# **Intel<sup>®</sup> Mobile Pentium<sup>®</sup> II Processor Specification Update**

Release Date: September 2000

Order Number: 243887-024

Old Mobile Pentium® II Processor in Mini-Cartridge Package Label with Supplier Matrix Mark

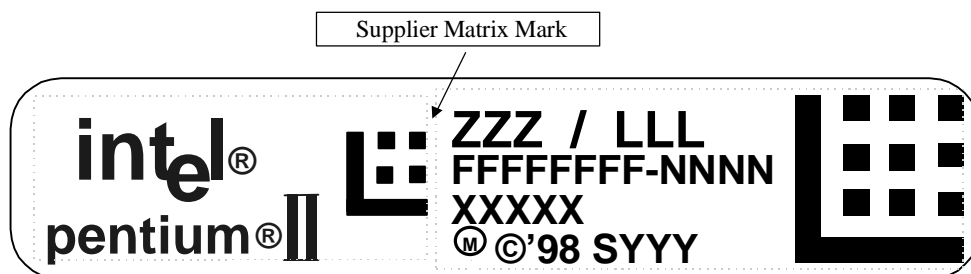
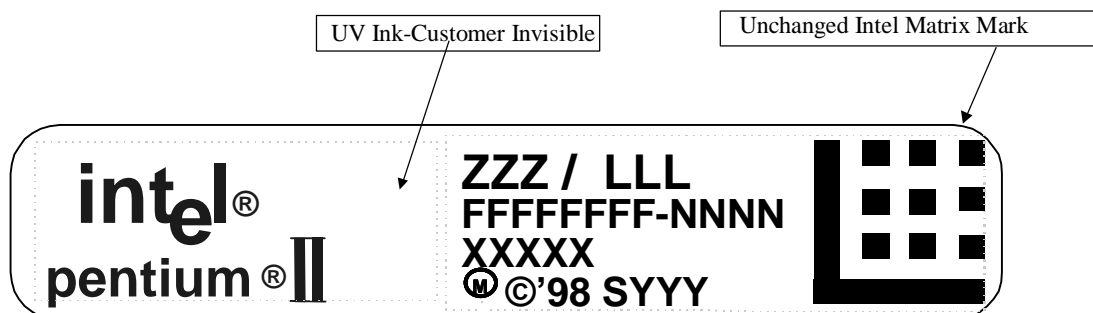
New Mobile Pentium® II Processor in Mini-Cartridge Package Label with Supplier Matrix Mark Removed

**Figure 5.6. Cross Sectional View with Vertical Dimensions**

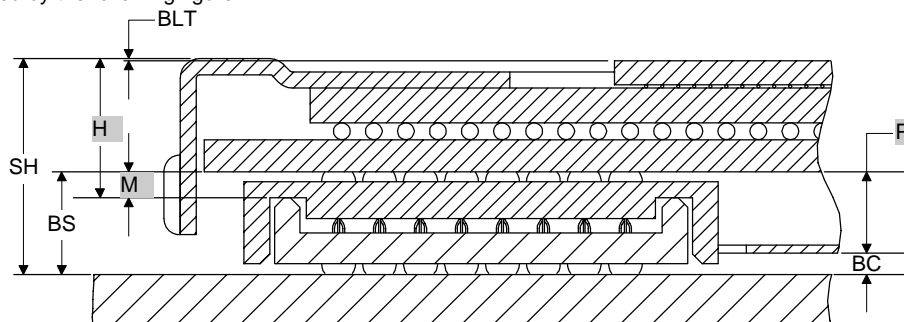
### B1. Misabeled Vertical Dimension Parameters

Figure 5.6 in the *Mobile Pentium® II Processor at 233 MHz, 266 MHz, and 300 MHz* datasheet should be replaced by the following figure:

**Figure 5.3. Surface-Mount BGA1 Package—Top and Side View**

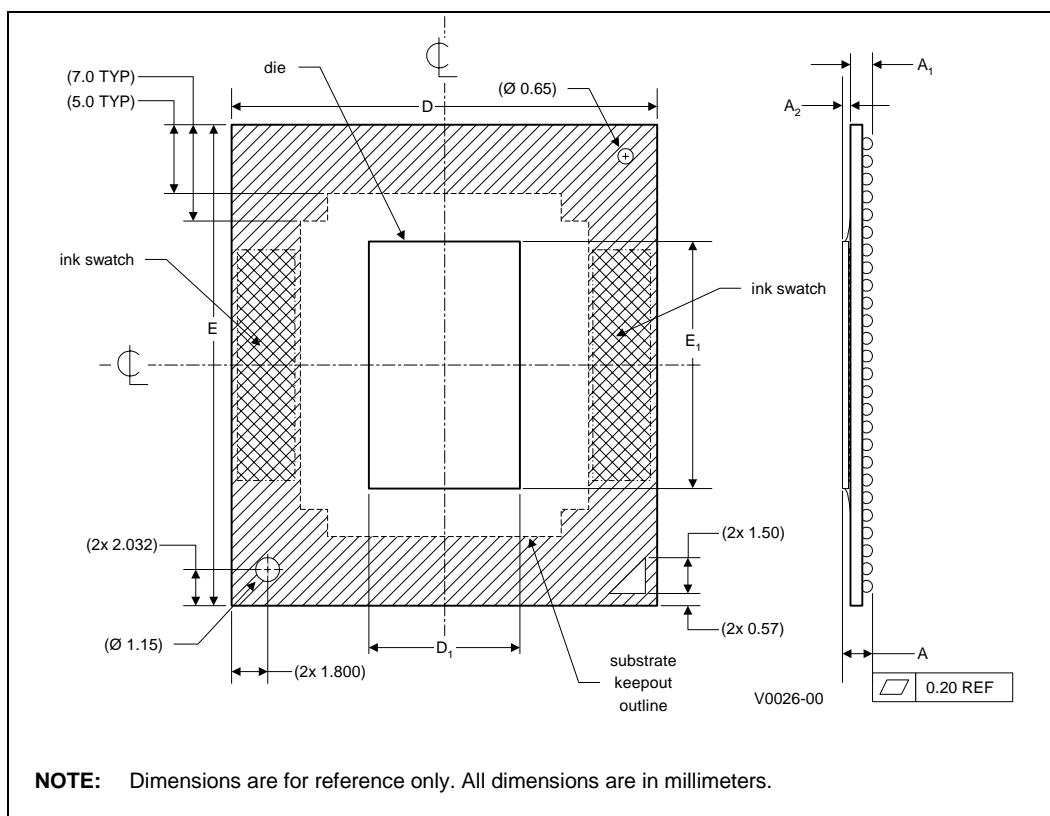
The following table and figures show the updated mechanical specifications for the BGA1 package, listed as Table 5.2, Figure 5.3 and Figure 5.4, respectively, in the *Mobile Pentium® II Processor in BGA Package at 366 MHz, 333 MHz, 300PE MHz, and 266PE MHz* datasheet.

Figure 3.3 Generic Clock Waveform

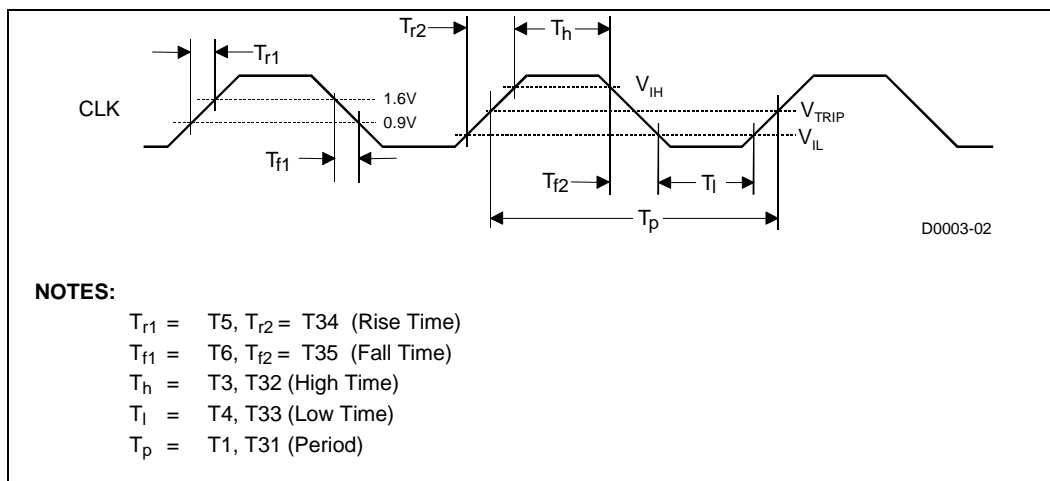
## B14. Generic Clock Waveform Figure

Figure 3.3 in *Mobile Pentium® II Processor in Mini-Cartridge Package at 366 MHz, 333 MHz, 300PE MHz, and 266PE MHz* datasheet (Order Number 245108), and the *Mobile Pentium® II Processor in BGA Package at 366 MHz, 333 MHz, 300PE MHz, and 266PE MHz* datasheet (Order Number 245106) has been updated. The following figure is to replace the ones in the above documents.

Figure 1. TAP Gageable Thread Clarification

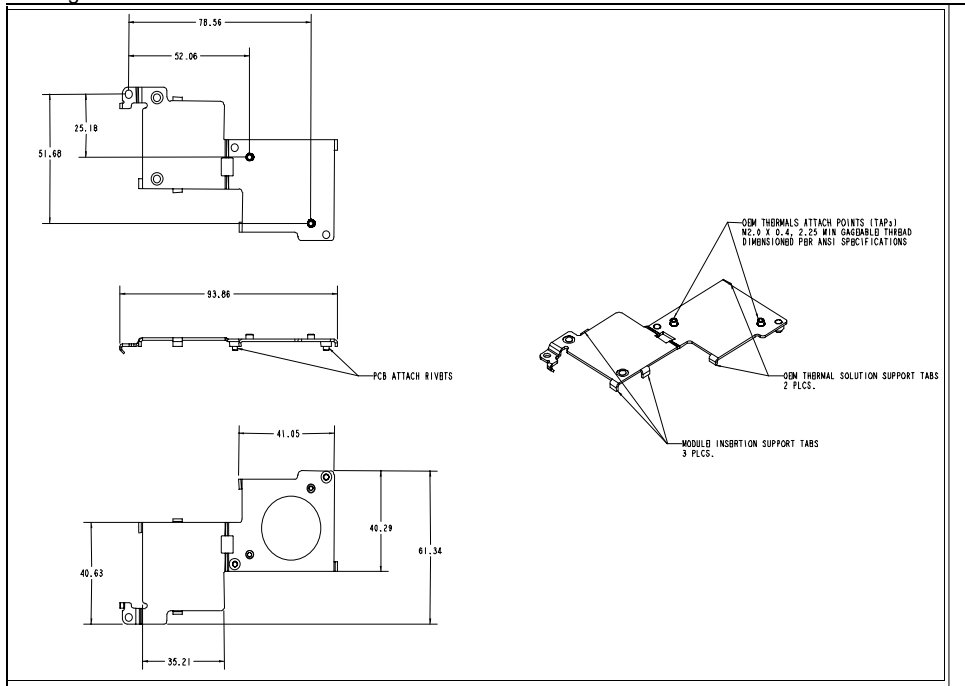
In the *Intel® Pentium® II Processor Mobile Module : Mobile Module Connector 1 (MMC-1)* and the *Intel® Pentium® II Processor Mobile Module : Mobile Module Connector 2 (MMC-2)* datasheets (Order Numbers 243667 and 243668, respectively), the thermal attach point (TAP) gageable thread specification was not clearly identified in Figure 14, of Section 5.2. The following is the TAP clarification:

OEM Thermal Attach Points (TAPs) M2.0 x 0.4, 2.25 min gageable thread dimensioned per ANSI specification.

See Figure 1 below for more information.
